Detailed Site Plan Departure from Design Standards Alternative Compliance McDonald's Ager Road

DSP-22001 DDS-23001 AC-23017

STAFF REPORT

McDonald's Ager Road

Figure 1: Parking Plan

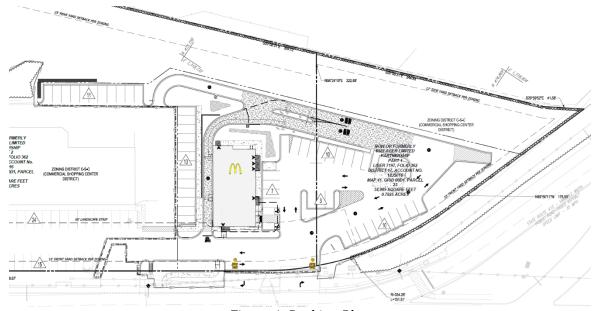
The proposed plan also includes adding 54 parking spaces to the existing parking lot, bringing the total number of parking spaces to 125. Specifically, 24 of the newly generated parking spaces will be located on the north side, while 30 will be situated south of the freestanding building.
